REPUBLIC AVIATION CORPORATION
FARMINGDALE, LONG ISLAND, NEW YORK
SERVICE DEPARTMENT

SERVICE BULLETIN NO. 17

INSTALLATION STEERABLE TAIL WHEEL

Reason for Change: To provide greater ease of taxiing under crosswind conditions.

Figure 9

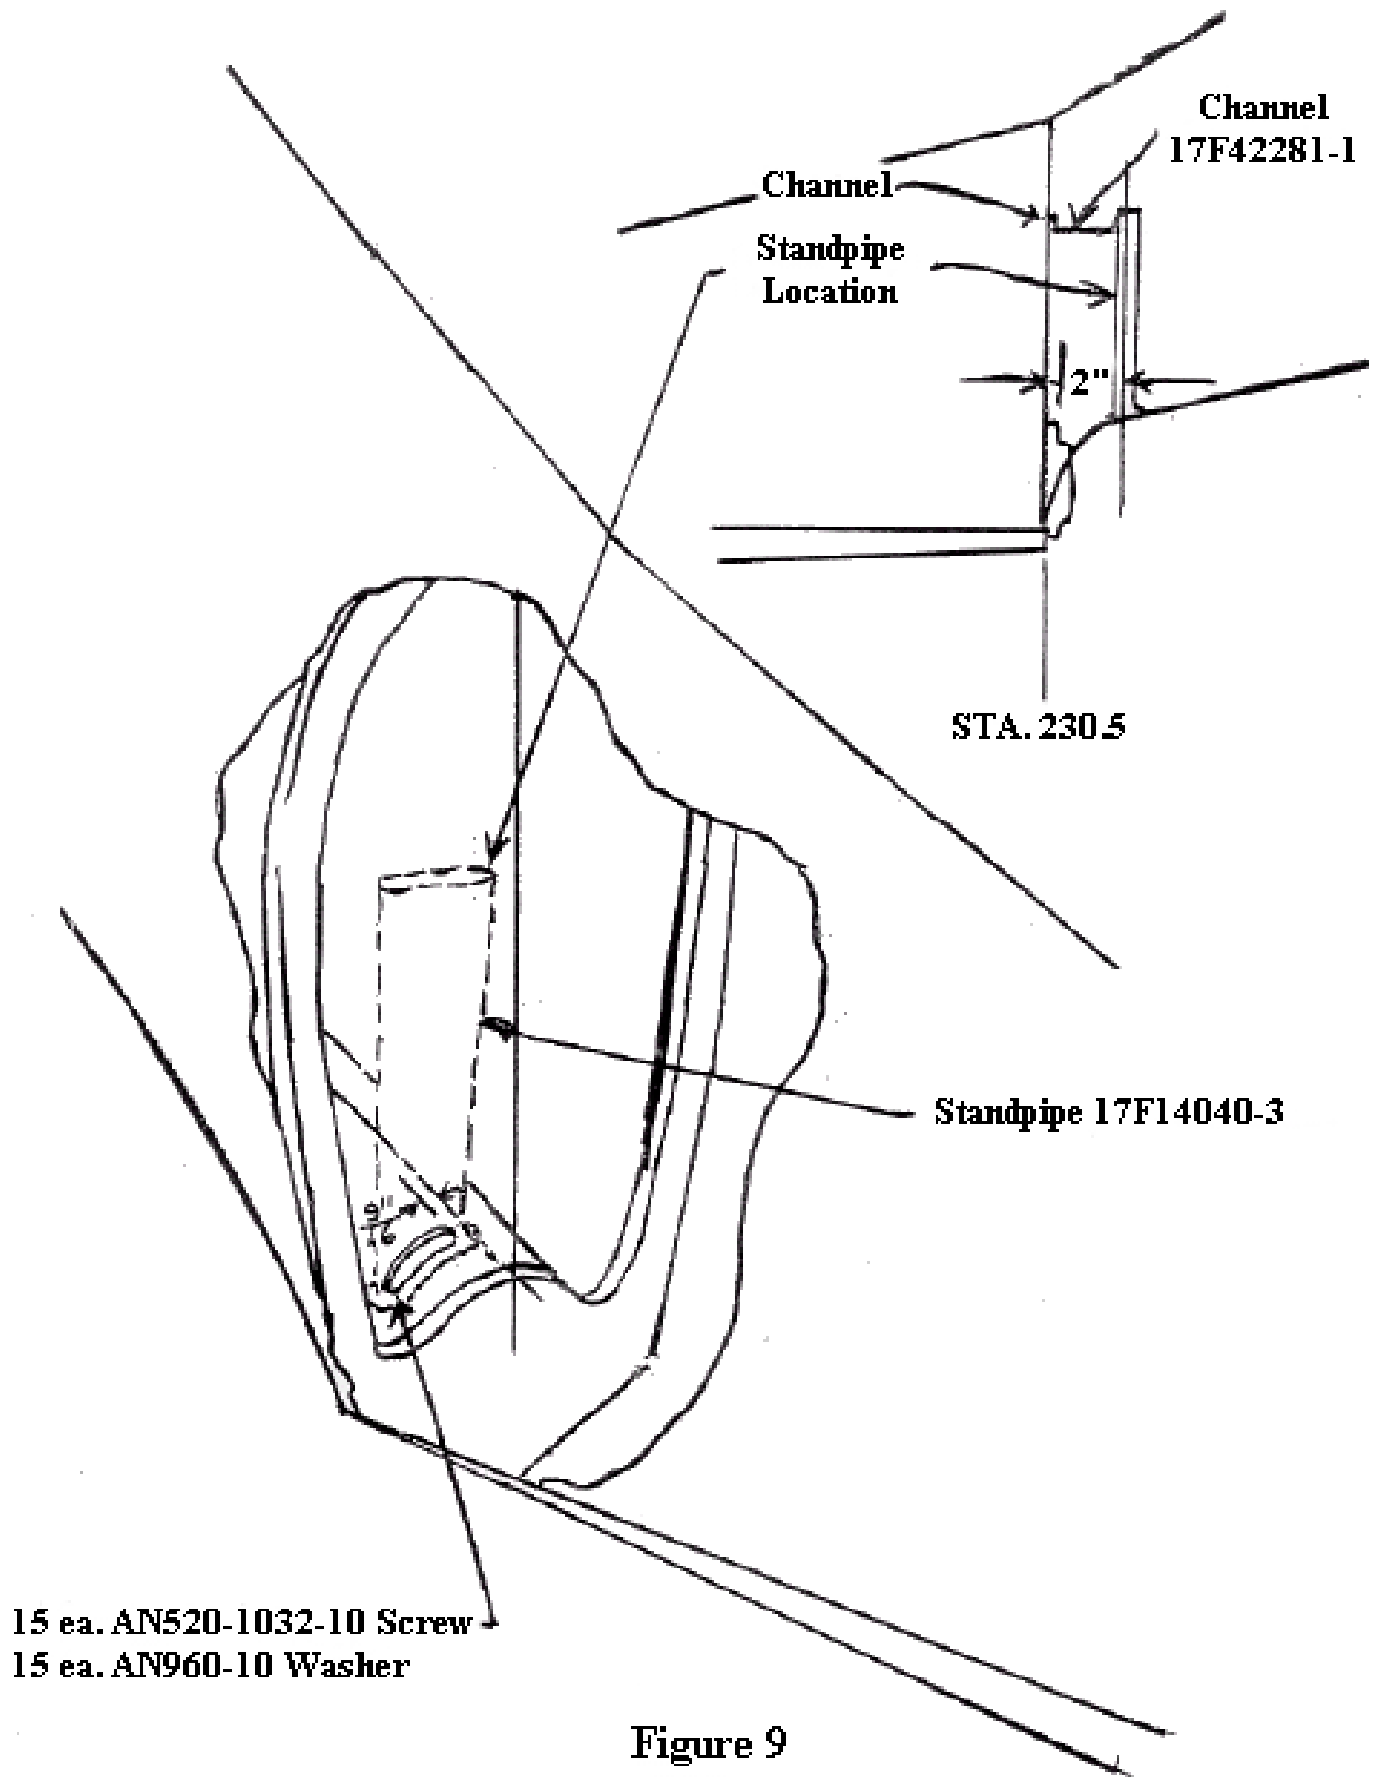
1. Install Standpipe 17F14040-3 and Plate 17F14040-5 as follows referring to Figure 9:
 - a. Place Plate 17F14040-5 against flange of Standpipe 17F14040-3 and check alignment of plate nuts on flange of standpipe with pilot holes in plate. Open up pilot holes in plate with a #10 (.194) drill being sure to compensate for any misalignment.
 - b. Draw a line on the hull 2 inches aft of the aft surface of the tail wheel shock absorber bearing.
 - c. Place plate so that inboard edge of hole in it is 9/16 inches to the right of the vertical centerline of the airplane. The long centerline of the elongated hole in the plate should be on the line drawn under (b) above. Scribe hole to be cut in hull using hole in plate as guide. Cut hole in hull.
 - d. Using holes in plate as guide, drill fifteen (15) #10 (.194) holes through hull.

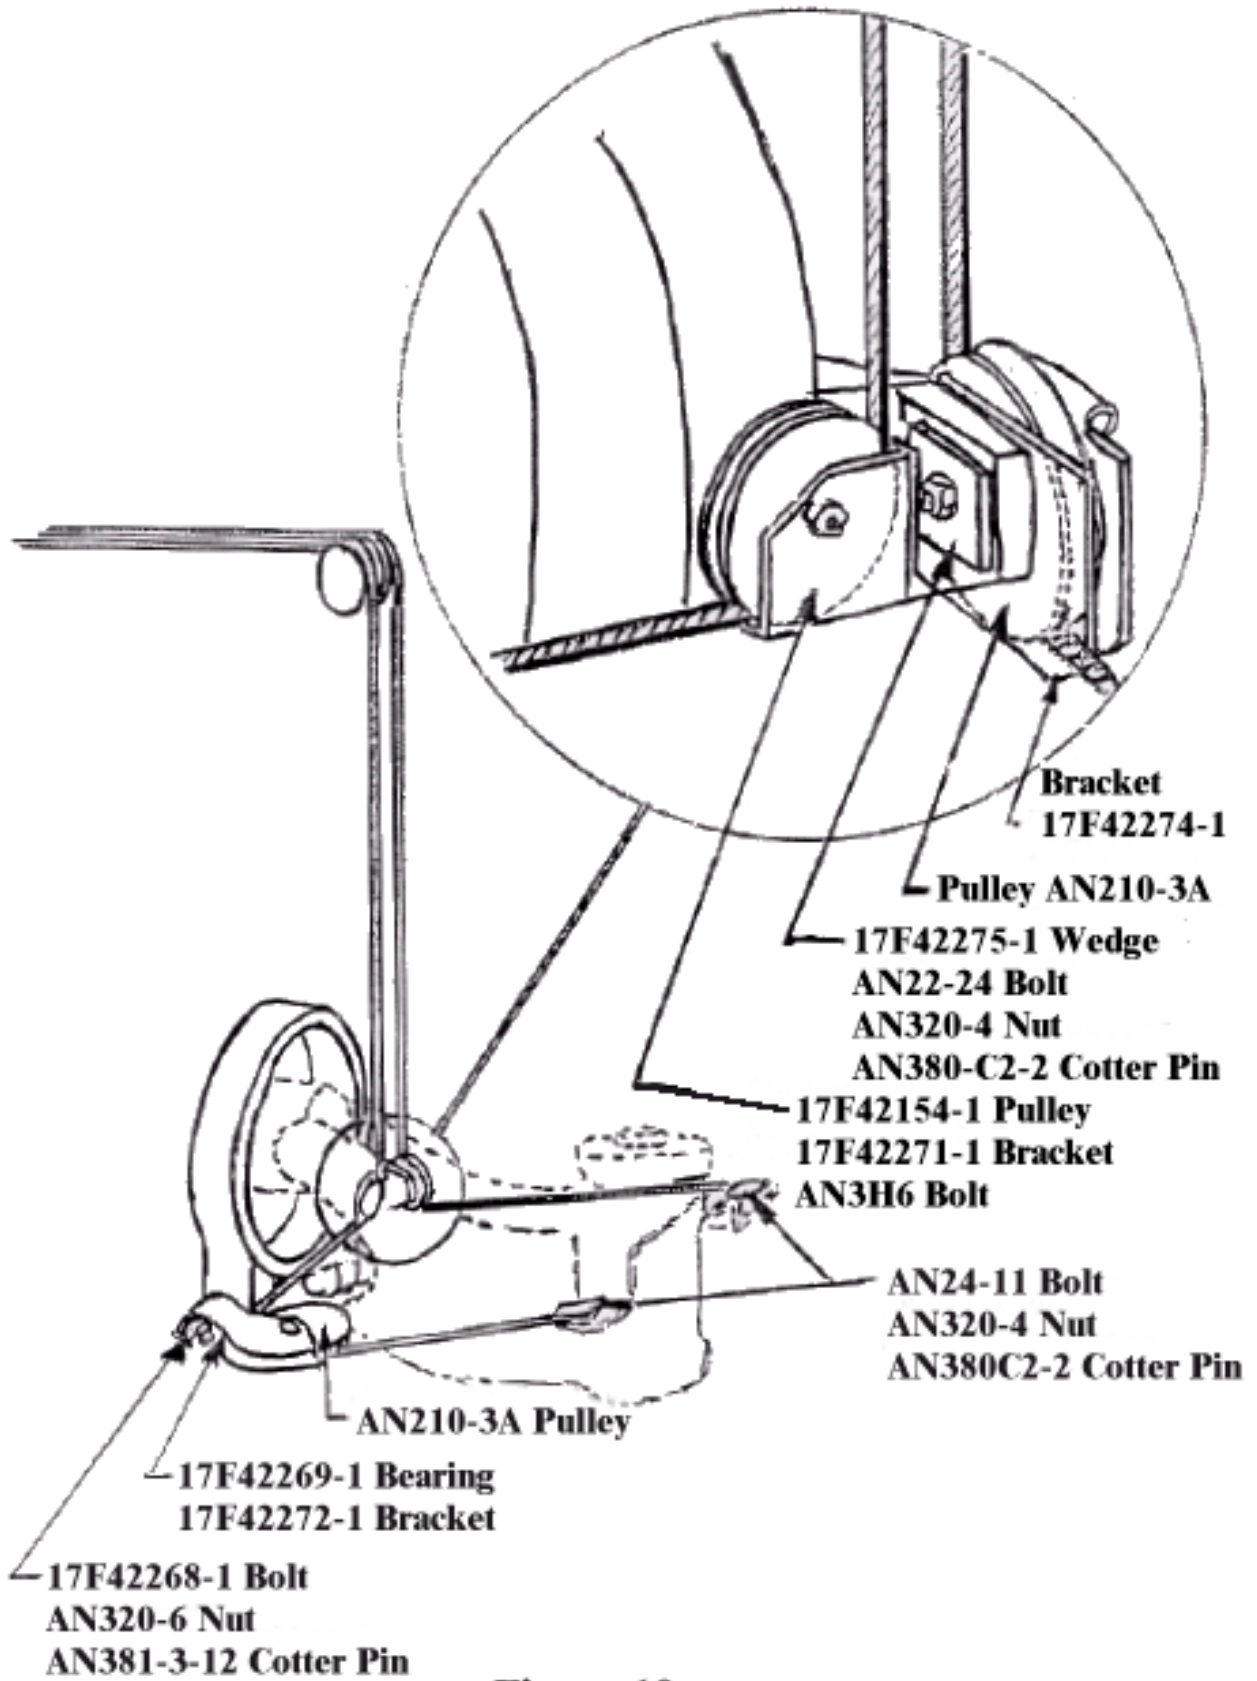
1. Reassemble Yoke and Fork Assembly onto the aft collar and piston of the shock absorber as follows referring to Figure 10.
 - a. Pass Bolt 17F42268-1 through ears on collar and yoke from right side.
 - b. ON left side place Bearing 17F42269-1 over Bolt and Bracket Assembly 17F42272-1 over bearing.
 - c. Fasten bolt with AN320-6 nut and AN381-12 cotter pin.
 - d. Fasten yoke to piston of shock absorber with original hardware.

- 1. Assemble steerable tail wheel control cables and pulleys as follows referring to Figure 10:
 - a. Pass right hand control cable around an AN210-3A pulley.
 - b. Assemble pulley to Bracket 17F42274-1 with an AN24-22 bolt.
 - c. Fasten pulley and bracket assembly to ear on aft shock absorber collar with Wedge 17F42275-1 and an AN320-4 nut and AN380C2-2 pin.
 - d. Pass left hand control cable around Pulley 17F42154-1 and assemble this on collar with Bracket 17F42271-1, AN3H6 bolt and AN936-B10.

Figure 11

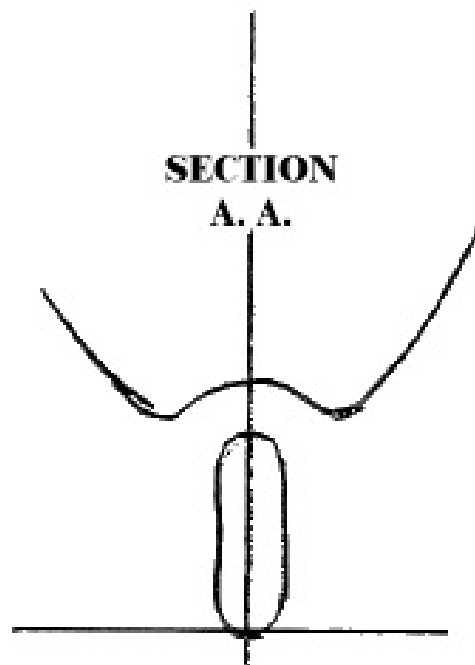
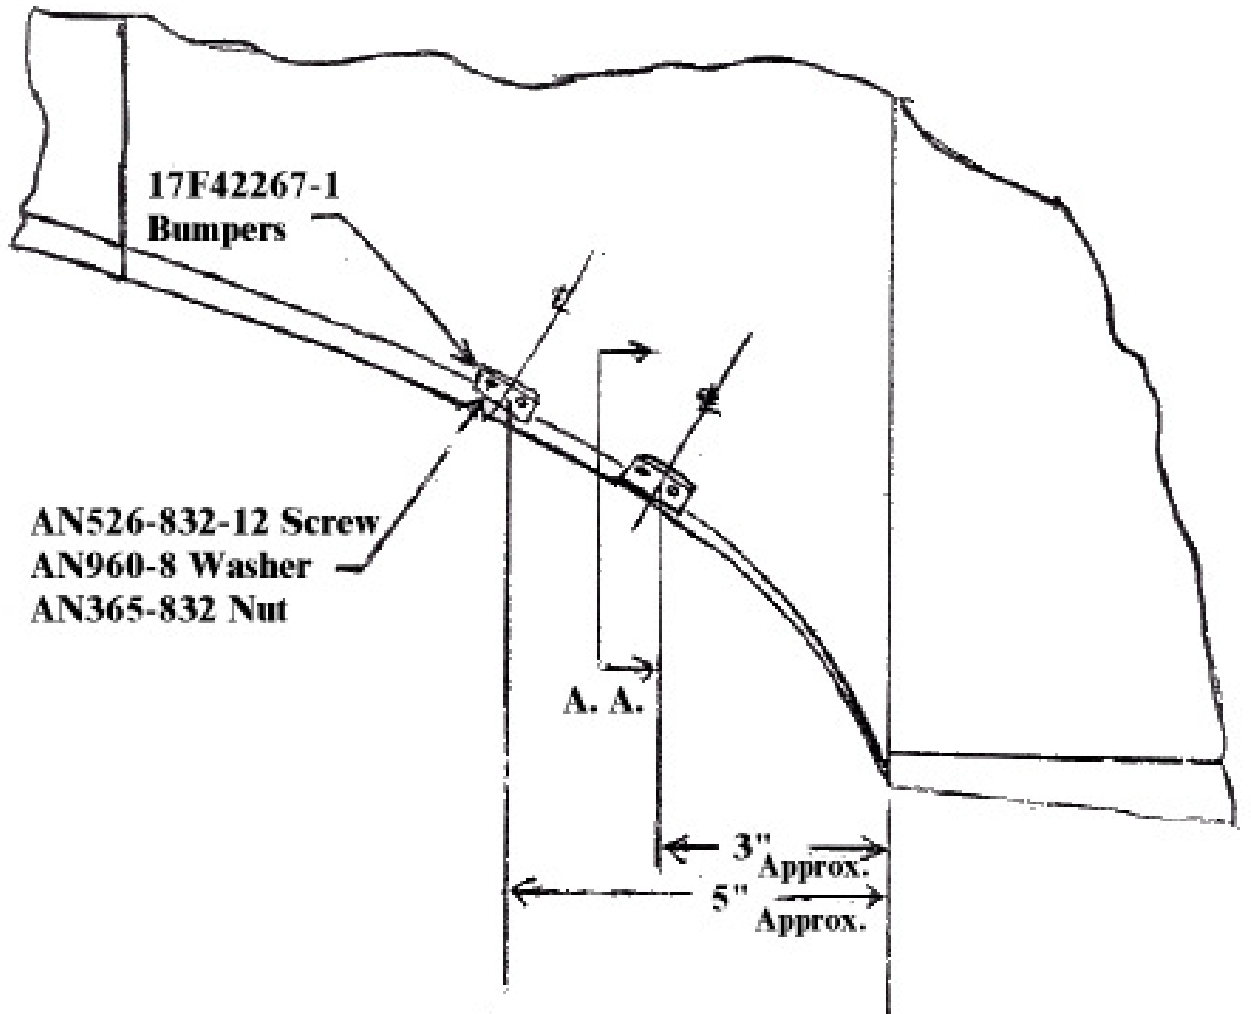
- e. Install Channel 17F42281-1 in place as shown picking up two existing bolts through bulkhead Station 230.5.
- f. Install two Bumpers 17F42267-1 as follows referring to Figure 11:
 - (1) Position of bumpers on right side of tail boom is to be determined by tail wheel fork in retracted and full swivel position. Mark location of interference with fork on tail boom.
 - (2) Place bumpers at points of interference and using holes in bumpers as guides drill four #19 (.166) holes for each bumper.

NOTE: If bumper overlaps skin splice, locate bumpers so that no holes are drilled in skin splice. If necessary use only two attaching holes.

- (3) Install each bumper with four AN526-832-12 screws, AN365-832 nuts and AN960-8 washers.
- g. Install standpipe and plate using fifteen AN520-1032-10 screws and AN960-10 washers first applying ample amount of UL-10161 (or equivalent) sealing compound between the plate and hull.
- h. Attach top of standpipe to channel so that edges of standpipe match edges of aft leg of channels using an AN23-8A bolt, AN365-1032 nut and AN960-10 washer. Use a #10 (.194) drill through top of standpipe for this bolt.
- i. Pass aft ends of steerable tail wheel control cables and pulleys as follows referring to Figure 10:

Figure 1

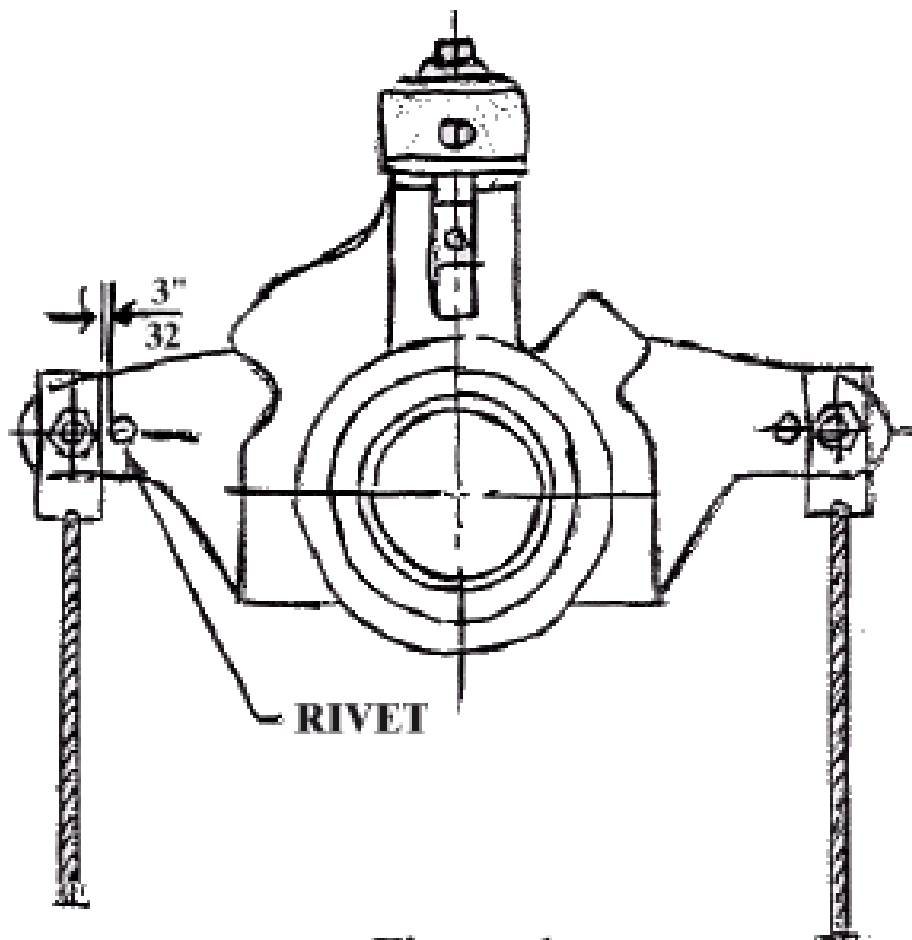
To prevent steerable tail wheel control cable terminals from swiveling one hundred and eighty degrees on the quadrant when the tail wheel is retracted, rivets are placed along side the terminals. If the cable terminals swivel there is danger of breaking the cables. Some of the early quadrants shipped in kits did not have these rivets installed. Please inspect these quadrants and if the rivets are not evident, install a rivet, screw or bolt so that there is $\frac{3}{32}$ -inch clearance between the inboard edge of the terminal and edge of the head of the rivet, screw or bolt.
